UNITED STATES PATENT AND TRADEMARK OFFICE

APPLICATION NO.	FILING DATE	FIRST NAMED INVENTOR	ATTORNEY DOCKET NO.	CONFIRMATION NO.
10/500,077	06/23/2004	Stephen Proulx	MCA-589A PC/US	5860
42754	7590	08/12/2010		
Nields, Lemack & Frame, LLC 176 E. Main Street Suite #5 Westborough, MA 01581			EXAMINER BOUCHELLE, LAURA A	
			ART UNIT 3763	PAPER NUMBER
			MAIL DATE 08/12/2010	DELIVERY MODE PAPER

Office Action Summary

DETAILED ACTION

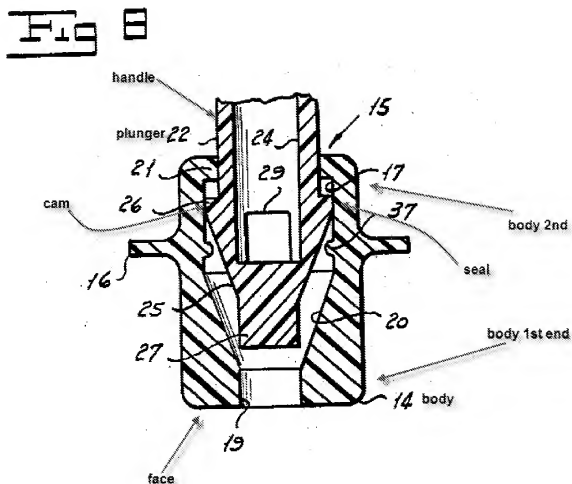
5. Regarding claim 1, the device of Mackal is considered to be a sterile device there is a gas tight seal between one end of the valve body and the other. Mackal discloses a fluid transfer device comprising a body 14 having a bore through its interior, a movable plunger 22 contained

within the bore, the body and the bore are formed of plastic (col. 2, lines 39-42), the body having a first end and a second end, the first end having a face designed to be connected to an upstream component 12 (see Fig. 2), the plunger having a first end and a second end corresponding to the first and second ends of the body, the plunger having a shape corresponding to that of the bore and having a diameter less than that of the bore (necessarily because it is contained within the bore), a port formed on the second end of the plunger connectable to a downstream component 34 (see fig. 3), one or more seals 26 between the plunger and the bore to form a liquid tight seal between the plunger and the bore (col. 4, lines 50-54), the first end of the plunger when in a closed position being in alignment with the face of the body forming a sterile barrier (col. 4, lines 36-41) and a surface capable of being steamed ("a steamable surface" is considered to be a functional recitation, and *any* surface is capable of being steamed), a cam slot formed in the body (between inwardly extending wall 21 and annular rib 37), and a cam 26 formed on the outer surface of the plunger and contained within the cam slot, and a handle (the outer surface of the plunger that extends out of the body) to move the plunger within the bore from a closed to an open and then back to a closed position. See Fig. 8 copied and labeled below.

- 6.
7. Regarding claim 2, the bore is a central bore formed through the entire length of the body (col. 2, lines 35-37, see fig. 8 above).
8. Regarding claim 16, Mackal discloses the sterile transfer device as described above, the bore having three sections each with a different diameter, the first section is the lower portion having the smallest diameter, the second section is the tapering middle section, and the third section is the top portion having the largest diameter. See Fig. 8 above.

9. Regarding claim 17, the bore has a first set diameter (bottom portion), a second set diameter (top portion) having a diameter greater than the first set diameter, and a transition section (tapering middle section) between the first and second sections.

10. Regarding claim 18, the transition section has a linear progression in diameter (see Fig. 8 above).
11. Regarding claim 19, the plunger has an opening 29 adjacent the first end and fluid channel 24 connecting the opening to the second end of the plunger (col. 4, lines 44-50).

12. Regarding claim 20, the seal 26 is located on the outer surface of the plunger. See fig. 8 above.
13. Regarding claim 25, Mackal discloses the device as described above, and wherein the face includes an opening 19, and a portion of the plunger is contained within the opening of the face. See Fig. 9.

fig. 3), one or more seals 26 between the plunger and the bore to form a liquid tight seal between the plunger and the bore (col. 4, lines 50-54). See Fig. 8 copied and labeled below.

18. Regarding claim 31, the one of more seals 26 form a liquid tight seal between the plunger and the bore when the plunger is in the open position. See Fig. 8.
